REQUEST FOR INFORMATION

Project Name: SAMPLE PROJECT - Example Warehouse Extension

RFI No: 01

Regarding - Base Plate Size Conflict – Column Schedule vs Detail 3

SKETCH - BASE PLATE BP1 (not to scale)

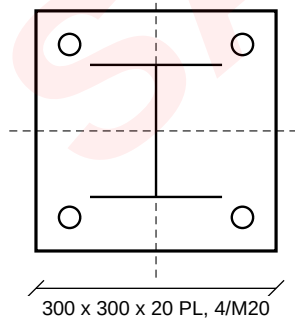
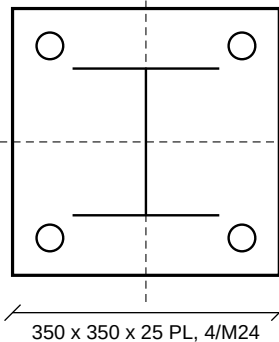
The column schedule on S-101 lists base plate BP1 as **300x300x20** with 4/M20 cast-in bolts. Detail 3 on S-201 shows the same columns (Grid A / 1-6) with a **350x350x25** base plate and 4/M24 cast-in bolts. Please confirm which size governs.

CONFLICT

Proposed solution: Model BP1 as 350x350x25 with 4/M24 cast-in bolts per Detail 3 (larger plate is conservative) and update the column schedule at the next revision. Please confirm or advise otherwise.
